MONTGOMERY COUNTY HISTORIC PRESERVATION COMMISSION STAFF REPORT

Address: 1811 Brighton Dam Rd., Brookeville Meeting Date: 8/14/2019

Case Number: 23/72-15A REVISION Staff: Dan Bruechert

Proposal: Building Addition

Figure 2: East elevation of the approved side-projecting rear addition.

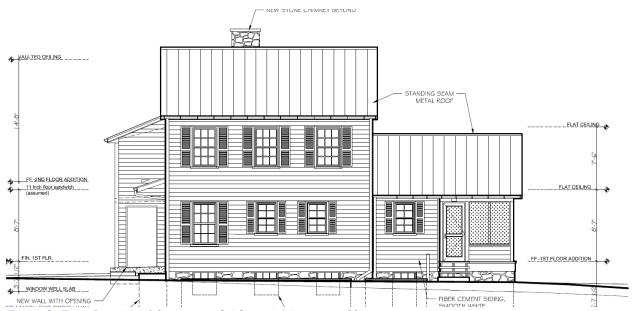
In 2015, the applicant presented a proposal to remove the existing, non-historic, right side addition and construct a 33' (thirty-three foot) wide addition to the east of the historic house and to complete a rehabilitation of the historic house. A side addition was deemed most appropriate due to the fact that the historic resource is a single pile house that sits on the bluff above the road. After a preliminary consultation and subsequent revisions, the HPC approved a two-story, one room deep addition with a gable-roofed, screened-in porch to the north (rear). The screened in porch is inset from the east wall of the addition by 1' (one foot).

Figure 5: Proposed south elevation with 2nd floor porch and addition.

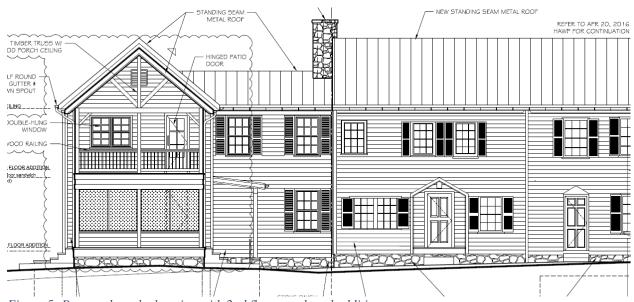
The applicant proposes to expand the approved addition on the second floor by 7' 5 ½" (seven feet, five-and one-half inches) to the north over the first-floor porch with an 8' 6" × 16' 7" (eight foot six inch by sixteen foot seven inch) second-story porch. The ridge of this rear facing gable is lower than the addition's principal gable and the second story walls will match the 1' (one foot) inset from the east wall plane. Materials and finishes for the proposed expansion are consistent with the previously approved work.

Staff finds that the proposed work is compatible with the historic house and the under-construction addition. This expansion will preserve the character of the historic building because it is placed away from the historic massing below the historic ridge (Standard 2). The design of the proposed work will be compatible in form with the historic construction, but is differentiated by using an open gable in the second-floor porch (Standard 9). Additionally, the addition is being constructed on an independent foundation so that it may be removed at some future date and not harm the form or integrity of the historic house (Standard 10). Staff finds that the new work will not be visible from the public right-of-way, as it is on the rear elevation of the house and the topography prevents any other view of the historic house. Staff additionally finds that while the addition does alter the massing of the addition, it does so in the location farthest from the historic massing to minimize its impact (per 24A-8(b)(1)). Staff additionally finds the size and massing of the

proposal are consistent with the historic house and previous HAWP, as the expansion is occurring over the existing foundation. Additionally, the double hung windows and the shutters in the proposed expansion match those on the first floor; and the fiber cement siding will help to differentiate the new construction from the historic. Staff finds the addition to be compatible in size, scale, design, and materials with the historic house (per 24A-8(b)(2)) and are consistent with the previous approval.

Staff recommends that the Commission <u>approve</u> the HAWP application under the Criteria for Issuance in Chapter 24A-8(b)(1) and (2) having found that the proposal will not substantially alter the exterior features of the historic resource and is compatible in character and the purposes of *Chapter 24A*;

1811 Brighton Dam Rd Brookeville, MD 20833 Jeffrey + Roshan Shirazi **EXISTING EAST CHIMNEY**

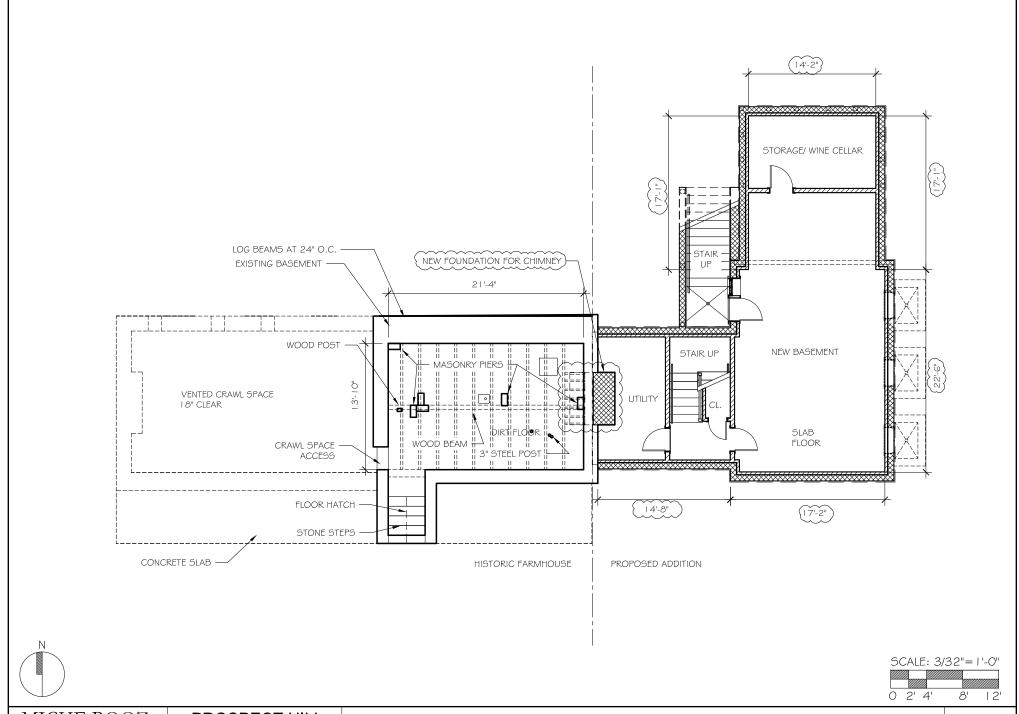
The East fireplace in the first floor Living Room is not original construction. In the MSA report the excerpt from *Historic Montgomery County,* Farquhar mentions that the room "had a hug fireplace in the early days". It is clear from the construction of the existing fireplace and chimney that they are not of the same material and assembly as the original West chimney (plaster over stone built around framing). Inspection of the basement foundation reveals evidence of the original hearth extending about 18" wider than the current hearth. Furthermore a modern brick chimney that vented a furnace in the basement has been added to the North side of the older chimney, clearly visible from the exterior photographs.

The east fireplace and chimney in question are non-functional. The throat of the fireplace is undersized for the opening area and it appears the flue above is undersized as well. The chimney is only about 16" thick and the combined fireplace chimney and furnace chimney are only about 32" wide. The available opening within the chimney is not sufficient for rehabilitation and it is our belief, given that this narrow chimney is not anchored to the house, that the assembly is a hazard to the structure and the occupants.

We proposed to replace the East assembly with a new larger fireplace and chimney clad with stone mainly from the site. We would like to design the dimensions of the fireplace to be similar to regional revolutionary-era construction and emphasize the prominence of this feature in the Living Room.

The new chimney would extend in plan about 2'-10" from the East wall of the house compared to the existing 1'-4". Our earlier design which we submitted for a preliminary HAWP on 11/16/2016 kept the existing chimney and planned the first floor Powder Room and second floor Bathroom and Laundry around those smaller dimensions. Due to the larger (and code-compliant) chimney we have had to expand the hyphen 12" to the East, 9" to the North and 9" to the South to allow accommodate the Powder Room and Bathroom. The Laundry could no longer fit on the second floor and we have relocated it to the first floor Mudroom. The Mudroom will need to be expanded 12" in the East-West dimension and 18" to the North.
